Office of Highway Safety

Road Safety Audit Review

Town:	Guilford	Date Reviewed:	June 13, 2019
Route:	Guilford Center Road	Mile points:	~ 6.35 – 6.85

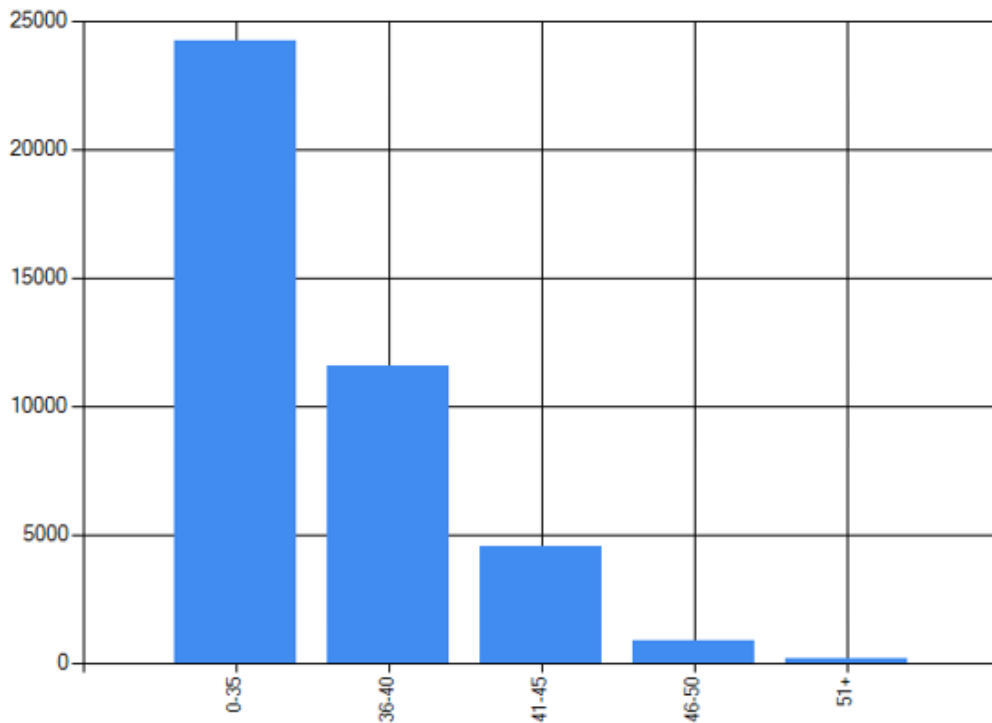
The Town of Guilford provided speed data for this road safety audit from a radar speed cart that was placed near the Broad Brook Grange by the Vermont State Police between June 7 and August 8, 2018, to capture speeds from vehicles traveling southbound.

The graph shown above displays the distribution of vehicles by speed ranges. The data shows that the speed that 85% of the traffic travels at in the southbound direction (85th percentile speed) was 40 mph and that the highest speed recorded was 83 mph.

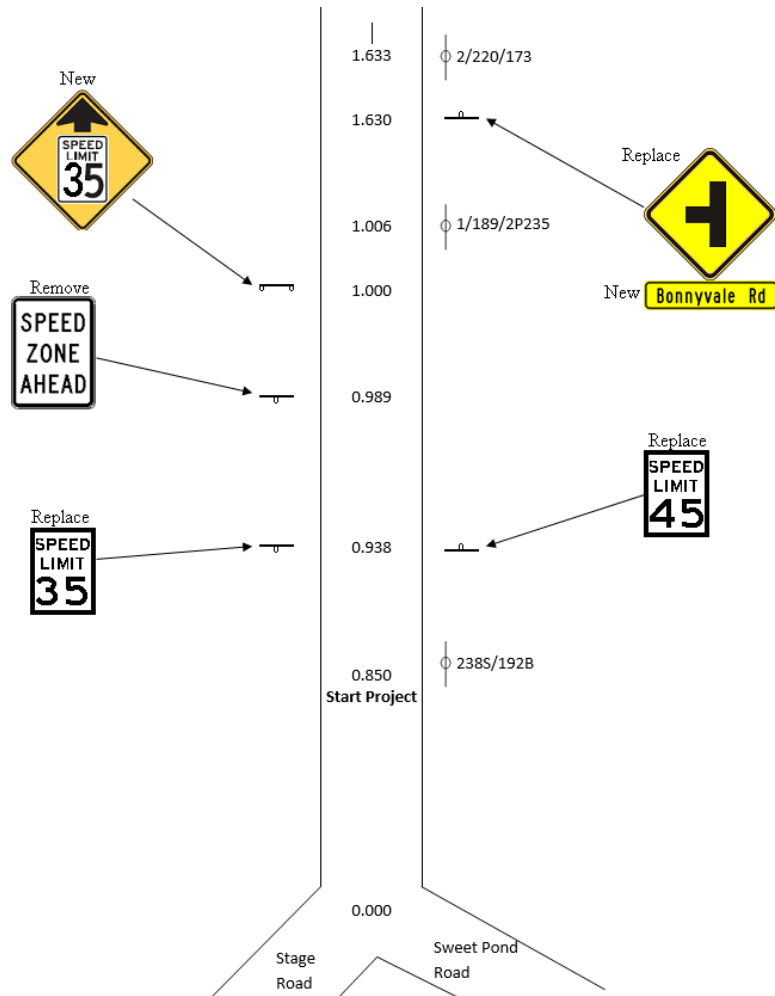
STP HRRR(23) was a VTrans project from the High Risk Rural Roads Program for the installations of signs on Guilford Center Road starting from Sweet Pond Road. The work done in the area of the road safety audit per this project is shown in the layout below. The work was completed during construction season 2018.

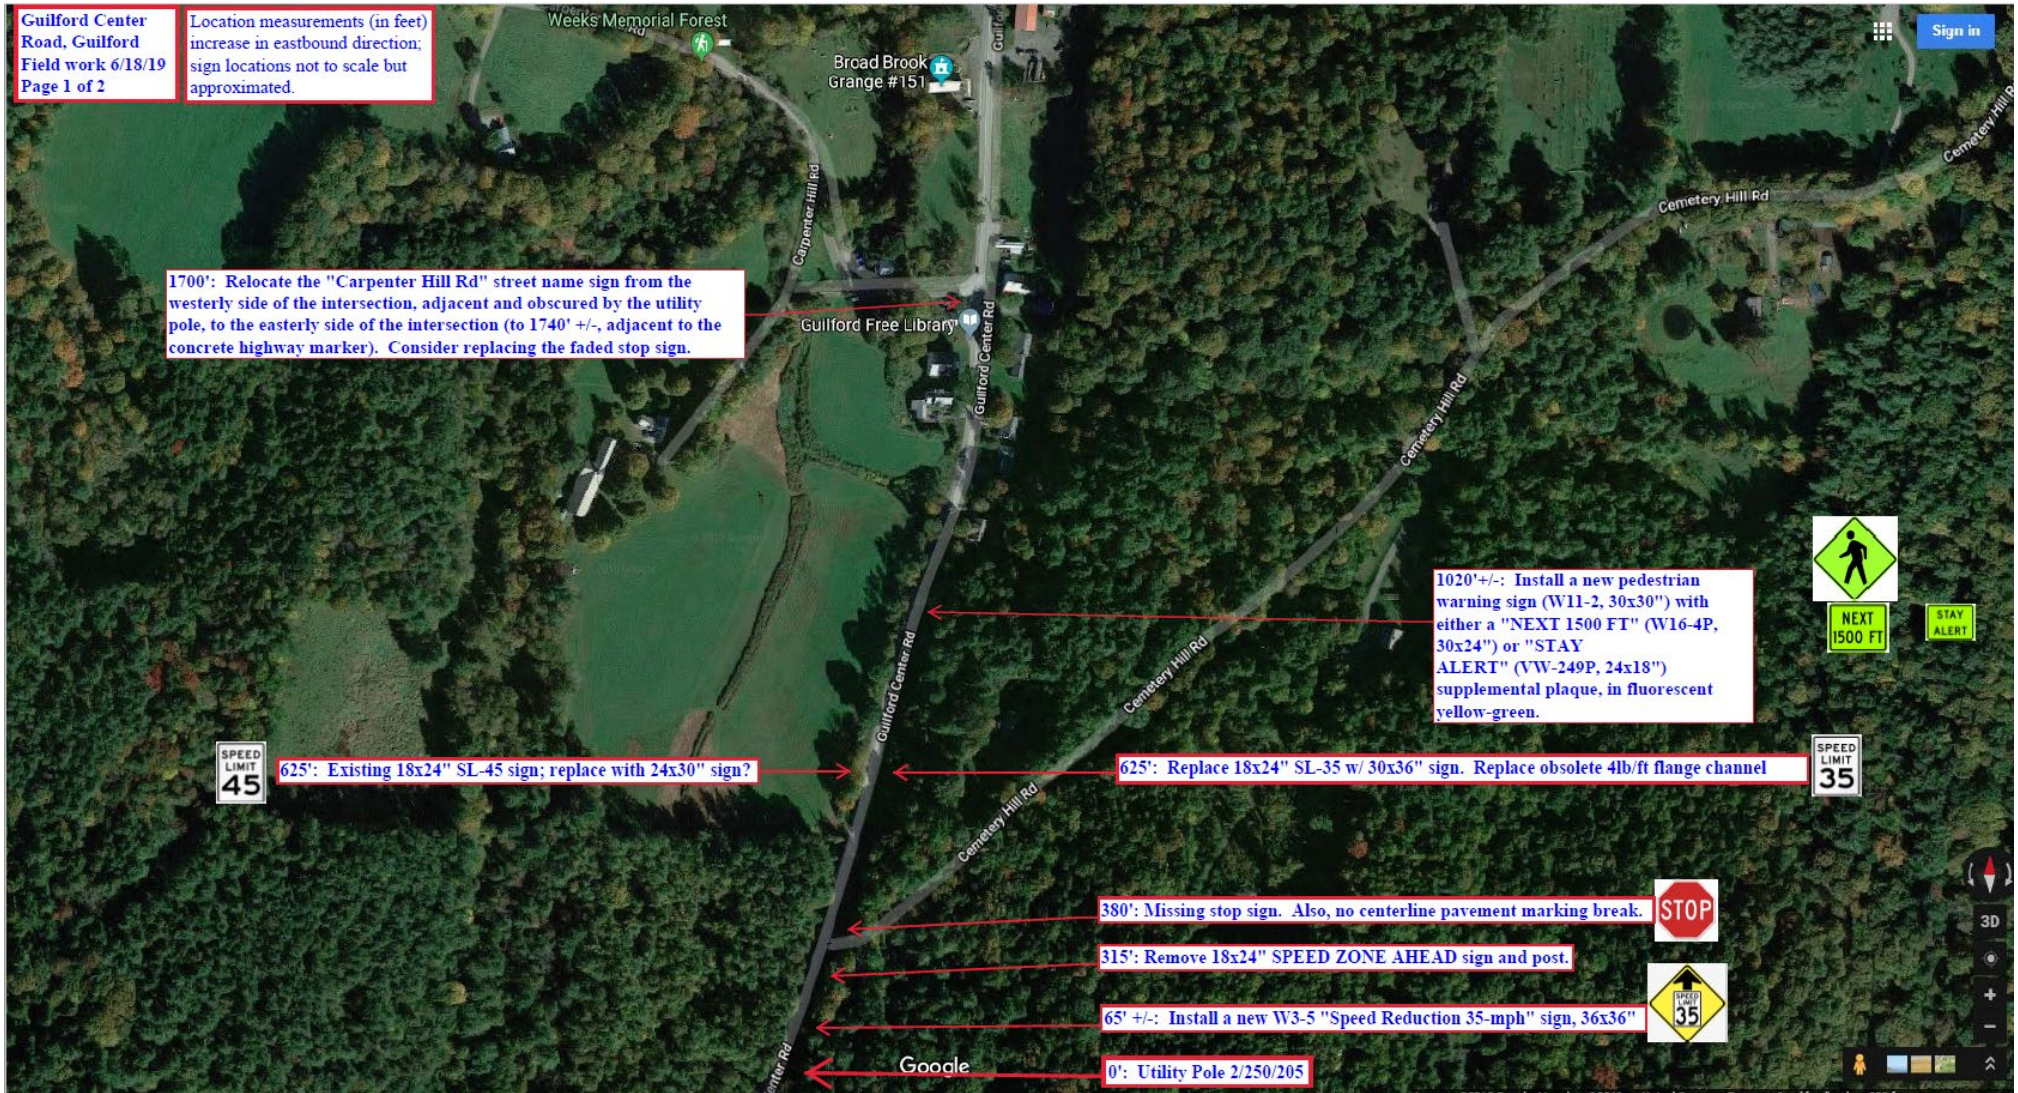
Concern 5: There is no Centerline Break at the Cemetery Hill Road Intersection

It was observed during the conduct of the road safety audit that there was no centerline break at the Cemetery Hill intersection. VTrans Standard 193 indicates that centerline breaks are to be present at all state highways and at town highways that have a stop sign installed. As per the previous concern, there is currently no stop sign at this intersection.

Short Term

- VTrans to mark in the field for the next time the centerline is painted to create a break (Note that, since the conduct of the road safety audit, the yellow centerline was painted and that a break was created. No further actions necessary).
